**City of East Bethel**  
**Planning Commission Agenda**  
**Planning Commission Regular Meeting**  
**Date: May 27, 2025**

**Request:** **PUBLIC HEARING.** A Site Plan, Conditional Use Permit (CUP), and four Variances for exterior storage on a property located at 21476 Johnson Street (city file 25-009).

**D&D CONTRACTING, LLC**  
PARKING STORAGE EXPANSION  
21476 JOHNSON ST. NE  
EAST BETHEL, MN 55011

Figure 1 - Yards Exhibit

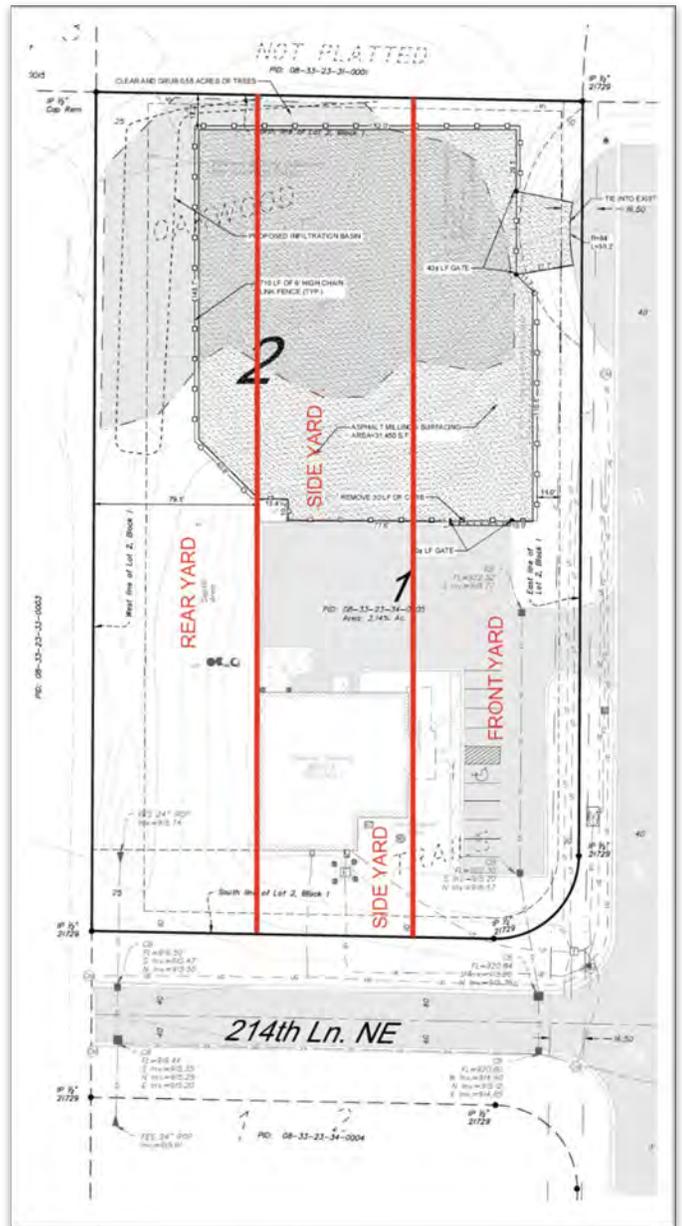
The landowner would like to construct a 31,450 square-foot fenced exterior storage area for storing equipment and other items related to their business. The landowner is allowed to exterior storage on this lot if it meets the standards in the City Code through a conditional use permit. However, the storage is shown in the side and front yard of the building, which is prohibited. They are seeking a variance to allow it in those areas due to the lot shape and existing building and septic locations.

The existing building is located on the south half of the lot and is set back on the front further than current code requires. Additionally, the rear yard area behind the existing building is taken up by a large septic field. Much of the lot that is vacant is in the northern portion, and most of that area would be considered the front and side yards. Other businesses in the area appear to have exterior storage, meaning it is a use found in this area. However, the variance is for the location of the use, not if they can have the use or not.

The Planning Commission could find that an exterior storage in the side and front yard on this lot is reasonable given the size of the lot and location of the existing building and septic.

The Planning Commission could find that exterior storage is unreasonable on this commercial lot.

Figure 2 – Alternative Variance Exhibit

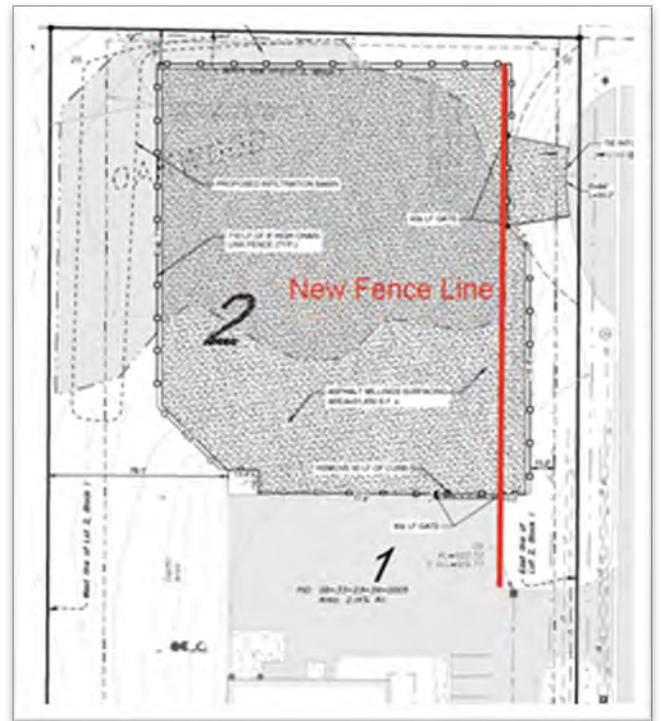
While most of the fences is setback at least 21 feet from the ROW, the gate jogs back on the north and is on the ROW easement for the temporary cul-de-sac. This means the variance would be for 0 feet setback as the setback is measured from the front lot line or any road easements.

The fence is required for the exterior storage use and is used for screening purposes. A fence to screen would not pose safety risk for any traffic as it is not located near a corner or in traffic visibility triangles.

Alternatively, the Planning Commission could find that a fence in the required front yard is reasonable but not the minimum action necessary and exterior storage at the existing parking lot line would be reasonable as it would create a consistent street edge.

Staff recommends that the applicant bring the fence and gate back to match the existing curb line of the parking lot to the south. This would increase the setback from 0 feet to approximately three feet at the closest point where the new driveway is proposed. This would reduce the request from 0 feet to 3 feet where 78 feet is required. The existing parking curb is set back around 34 feet on the lot if you exclude the roadway easement. This would reduce the overall size of the exterior storage as well and would leave more room for the required landscaping on Johnson Street. The Commission could recommend approval of the variance to allow a 6-foot fence in the front yard and add a condition requiring that it be moved to the 34-foot setback to mitigate the effect of the variances.
